Floor Plan for New Building

**File Number: 03186
Development Application DA06/0734
No:**

REDEVELOPMENT OF LUISINI WINERY (proposed new buildings for a restaurant, kiosk and environment centre including associated car park and landscaping), Lot 41 P 16167 Vol 1787 Fol 263, Luisini Winery 24 Lakeway Drive KINGSLEY WA 6026

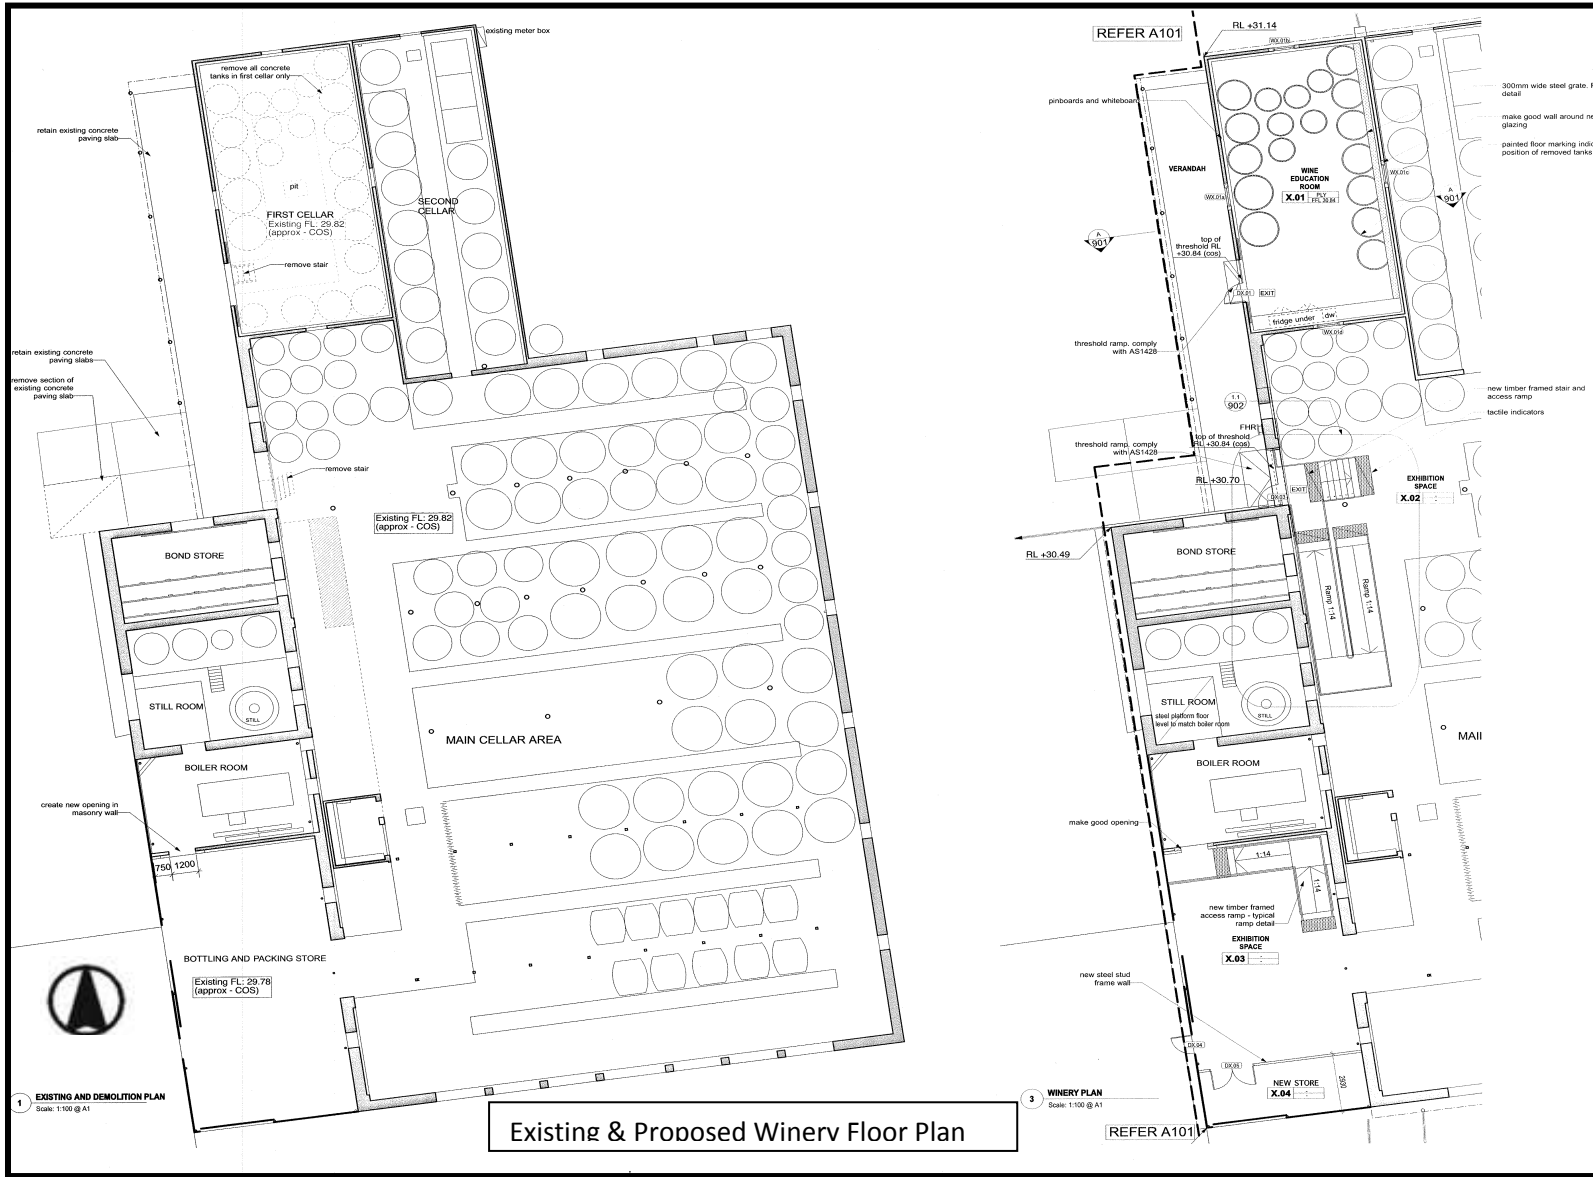
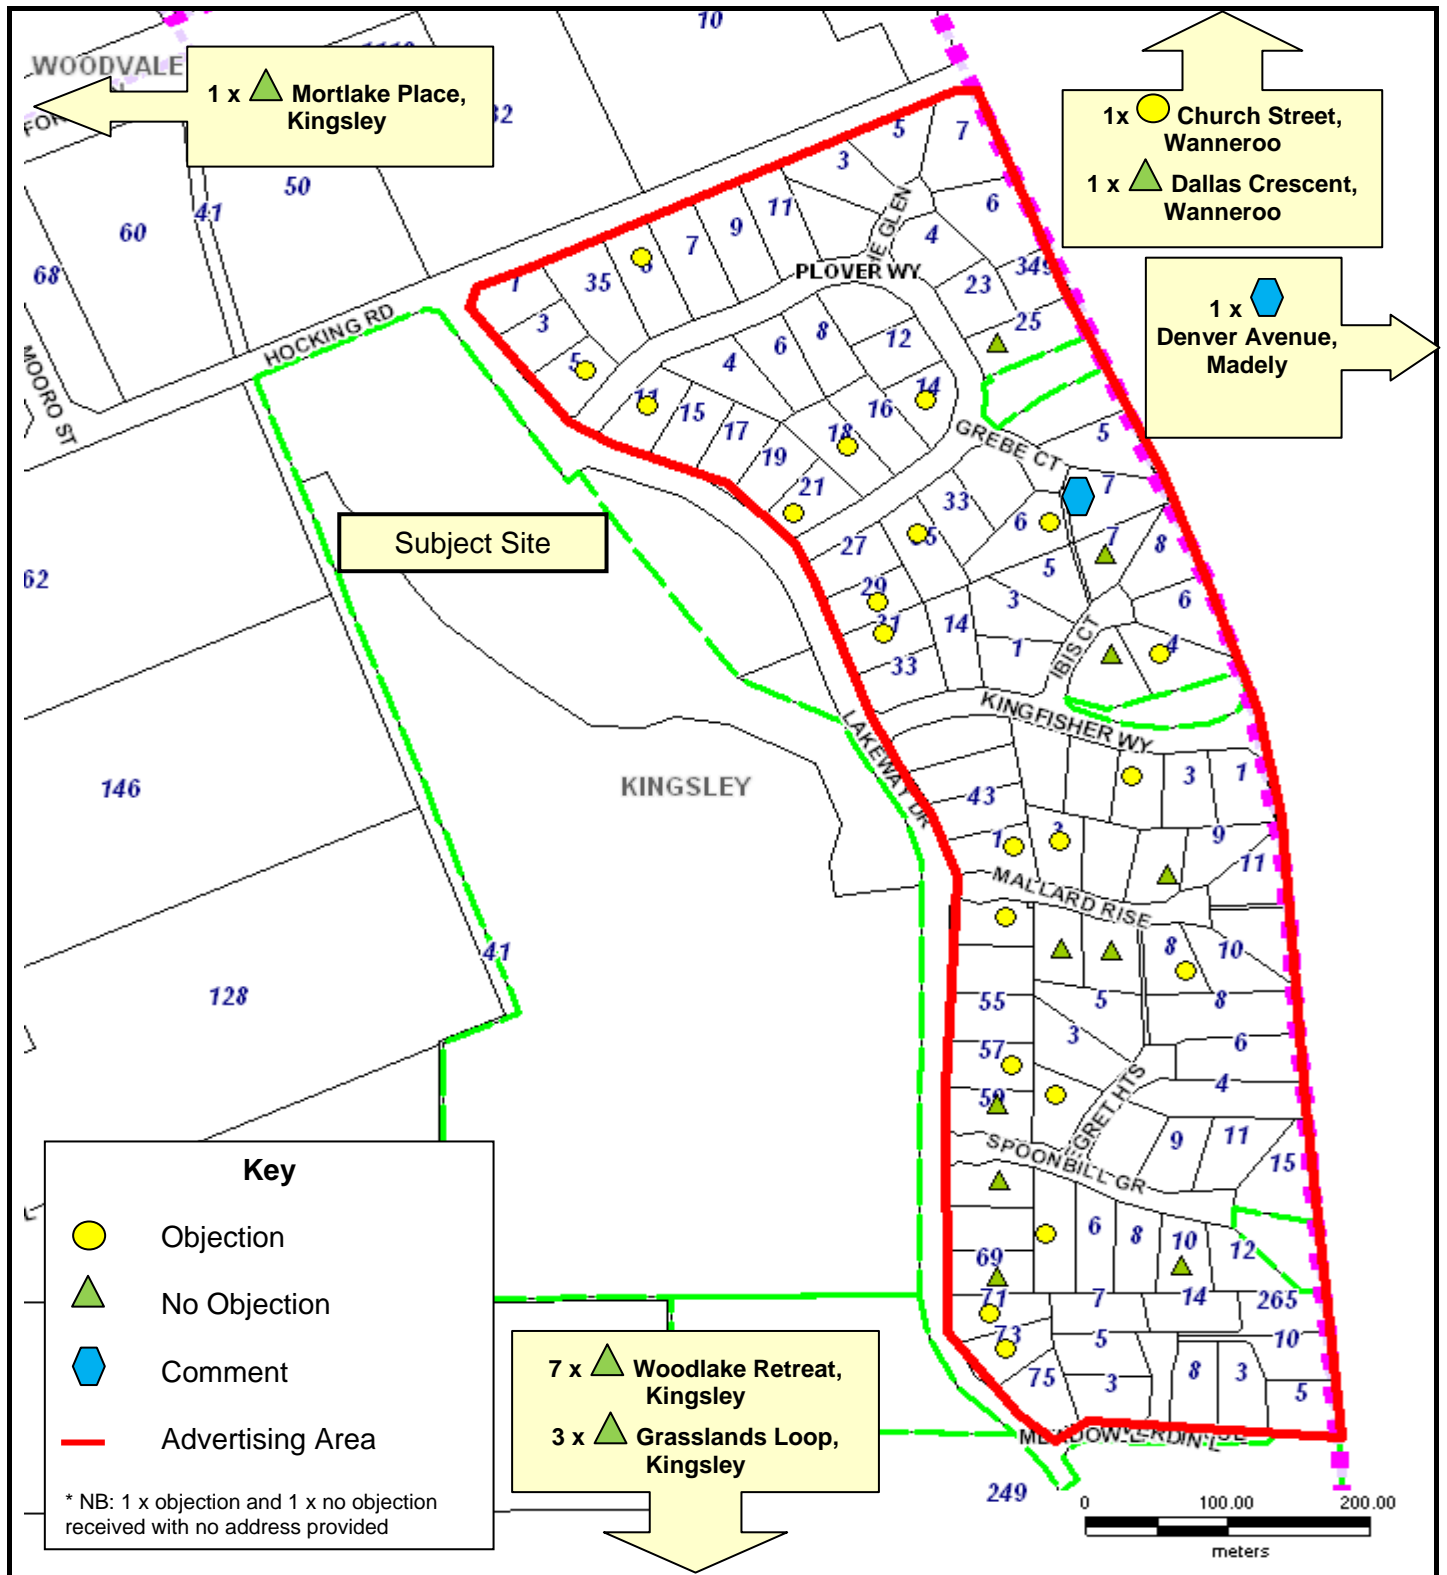
- (c) Amended plans being provided for approval of the Manager Approvals, Planning and Environmental Services, detailing the following revisions:
 - (i) the overflow car parking area deleted and a total of 87 formal car bays provided on-site and

- (ii) the extent of the outdoor seating area clearly identified on the floor plan
 - (d) The parking bays, driveways and points of ingress and egress to be designed in accordance with the Australian Standard for Offstreet Car Parking (AS2890). Such areas are to be constructed, drained, marked and thereafter maintained to the satisfaction of the City prior to the development first being occupied. These works are to be done as part of the building program
